NOTICE UNDER SECTION 96 OF ACT III OF 1901.

I beg to inform you that I intend building a shop on plot No. 11972Survey Sheet No. 208 situate in ...Street, Hydrabad Quarter.

PLAN OF PROPOSED SHOP
ON PLOT NOS 71 & 72-KB
LYAREE QB
SCALE 8"=1"

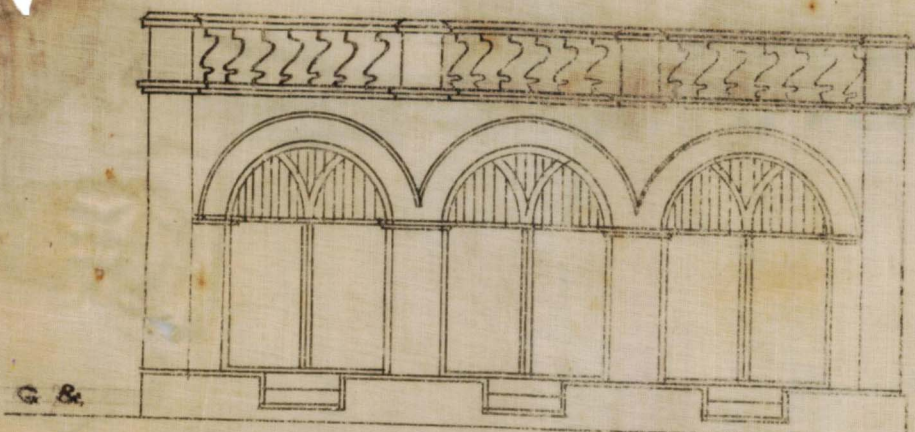
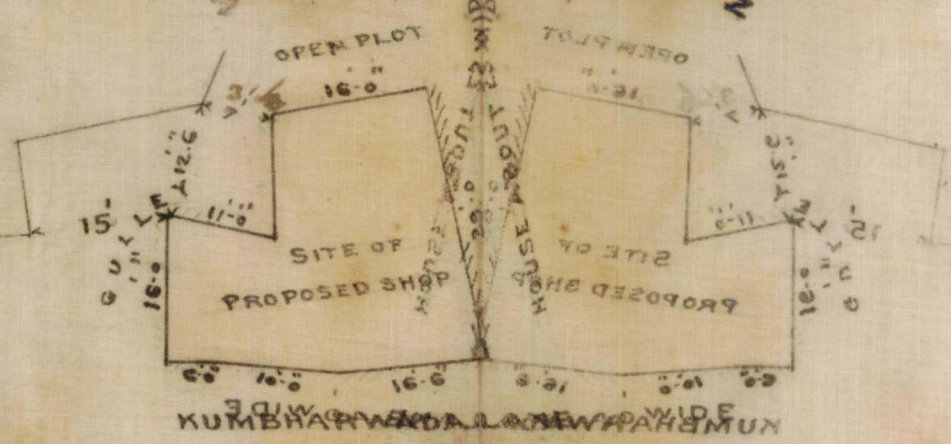
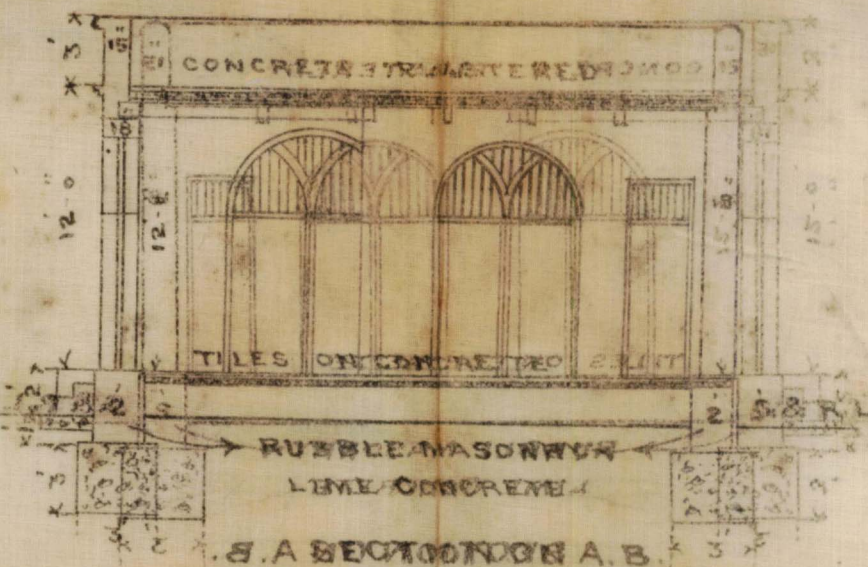
Strengthen that the wall towards the
north should be erected in his own limits
in order to strengthen the building as the
shop is pretty good in area.

A separate wall should be
built at the north of the plot for
stability to the building
